CONSERVATION TEAM CONSULTATION APPLICATION RESPONSE

APPLICATION REF:	25/01420/FP
CASE OFFICER:	SK
APPLICATION SITE:	Highover Farm, Highover Way, Hitchin Hertfordshire SG4 0RQ
DESCRIPTION OF WORKS:	Change of use and external alterations to former agricultural buildings comprising grade II listed threshing barn and non-listed courtyard buildings. Partial demolition of courtyard building between proposed Units 1 and 2 to facilitate access. Single-storey rear extension to facilitate Unit 10. Subdivision and two-storey rear extension to farmhouse to form Units 11 and 12. Erection of new building for two dwellings (Units 13 and 14). Partial demolition and modify building for cycle storage to Units 2 to 8 inclusive. Erection of building to accommodate 2 car port spaces for Unit 5 and refuse storage for Units 2-8 inclusive. Detached bin enclosure / cycle store buildings for Units 9 - 14 inclusive. Hard and soft landscaping in association with the provision of private and communal space. Boundary treatment, installation of 14no. EV charging points, installation of solar PV array on south facing roof slopes of Unit 14 and both the cycle and refuse storage buildings serving Units 2 -8 includ

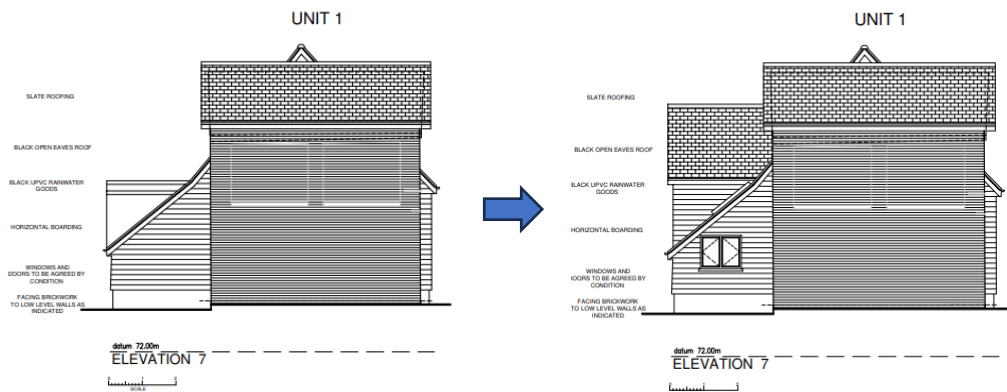
I previously advised that the window to Bedroom 1 becomes a horizontal long window (not a means of escape so an emergency door may be required on the side elevation facing the access). I don't know if a means of escape was required but what is now shown is a pair of side-hung casements. I was not anticipating this response and the top left hand corner of the window frame almost touches the roof verge. A single right-hand casement

would be preferable and would reduce cost if a double is not required as a means of escape.

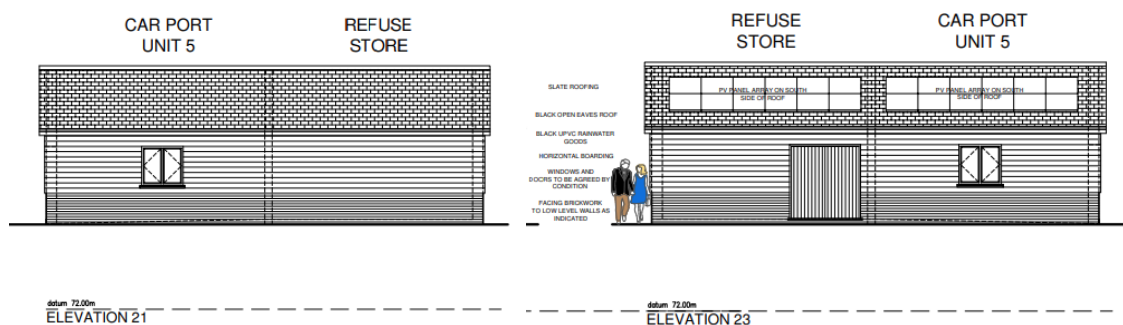
I have also noted the comments regarding bats, including Liz’s comments on 18 August 2025 which references the plan below which should be duly considered. I am prepared to accept the removal of the slates to carry out essential frame repairs on the understanding that both buildings will remain weathertight and that bat habitats would not be adversely affected.
